Subject: AP1000 COL Standard Technical Report Submittal of APP-GW-GLN-144, Revision 0 (TR 144)

TITLE: **AP1000 Design Control Document High Frequency Seismic Tier 1 Changes**

WESTINGHOUSE ELECTRIC COMPANY
AP1000 Licensing Design Change Document

This document provides Design Control Document (DCD) Tier 1 changes related to the seismic design spectra to provide conformance with previous DCD Tier 2 changes to address hard rock high frequency exceedances. Additional conforming changes to DCD tier 2 are also provided.

Figure 5.0-3
Horizontal HRHF GMRS
Safe Shutdown Earthquake

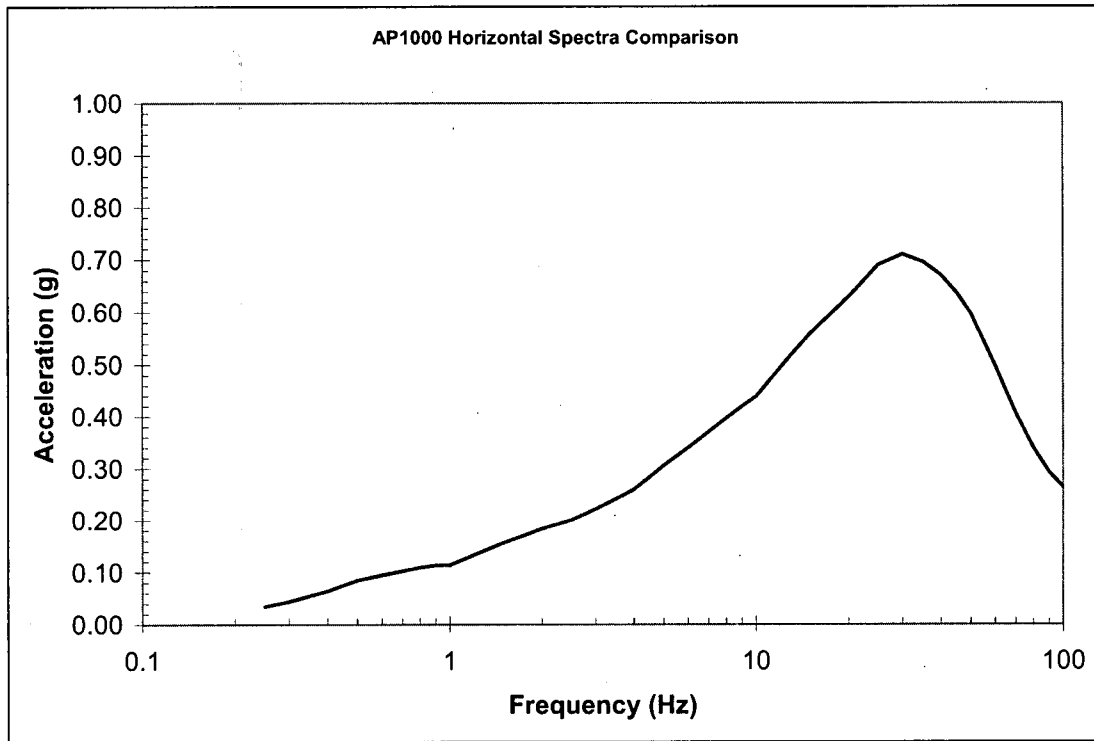
Structures, systems, and components for the AP1000 are evaluated for generic Ground Motion Response Spectra (GMRS) with high frequency seismic input at a site where the nuclear island is founded on hard rock. The spectra shown in Figure 5.0-3 and Figure 5.0-4 provide hard rock high frequency (HRHF) GMRS at the foundation level for both the horizontal and vertical directions for 5% damping. An actual site is acceptable if its site specific GMRS fall within the AP1000 HRHF parameters in Figures 5.0-3 and 5.0-4. No additional

Add Figures 5.0-3 and 5.0-4 as follows:

Figure 3I.1-1

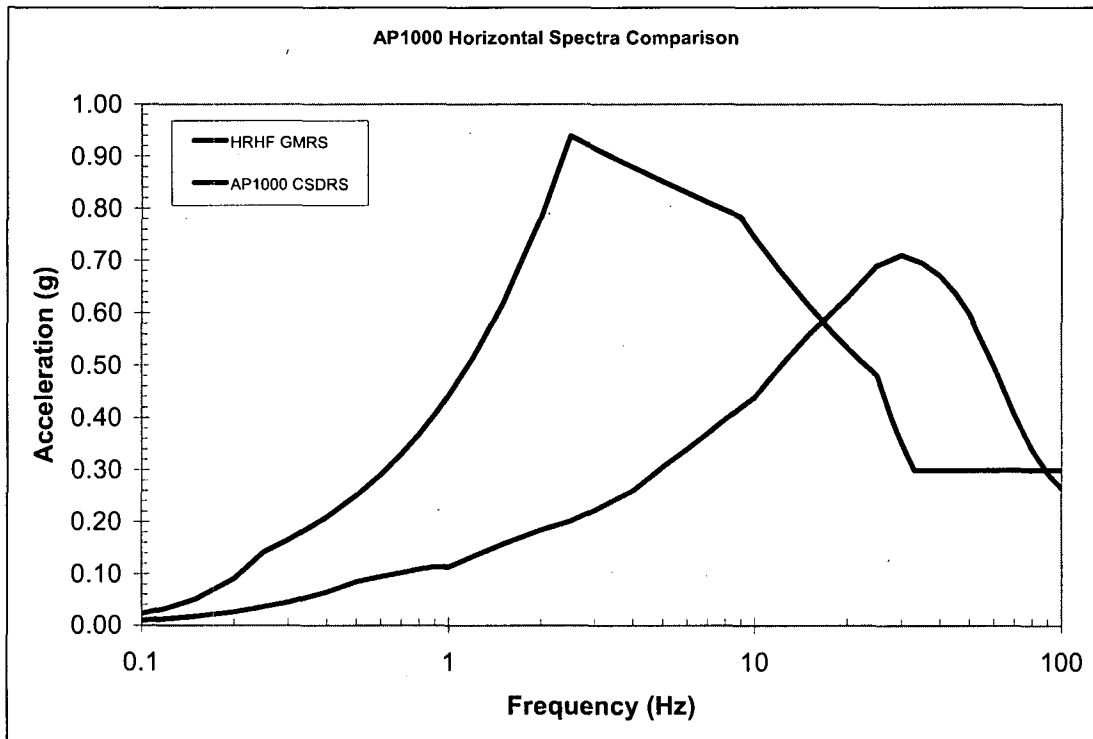
The HRHF GMRS included in the figures provided below for inclusion in Chapter 5 of DCD Tier 1 are modified from the version included in APP-GW-GLR-115 (Reference 4). The spectra in the figures provided below have an increase in amplitude over a portion of the frequency range. The modified spectra bound the site specific spectra for the COL applicants referencing the AP1000 Design Certification with hard rock sites. The use of the figures provided below is supported by the evaluations described in APP-GW-GLR-115. The HRHF GMRS included in these figures are bounded by the response spectra time history used for the evaluations in APP-GW-GLR-115. The same HRHF GMRS are included in revised Figures 3I.1-1 and 3I.1-2

Revise Figure 3I.1-1 as follows:

Figure 3I.1-2

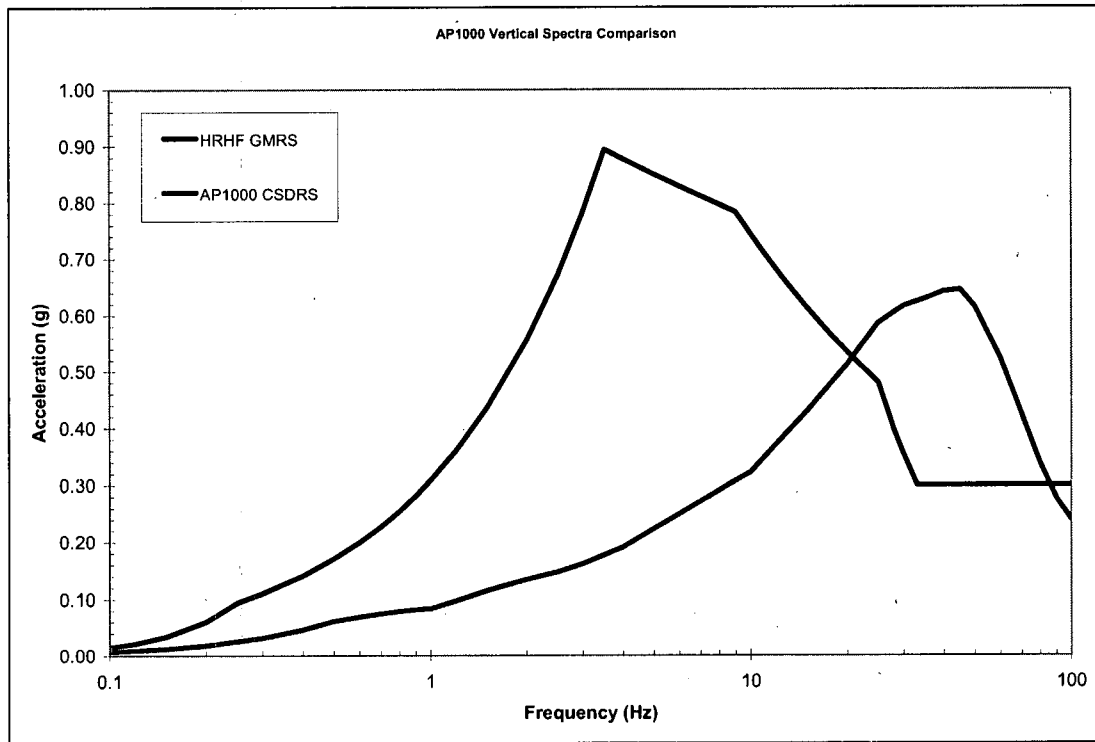
Revise Figure 3I.1-2 as follows:
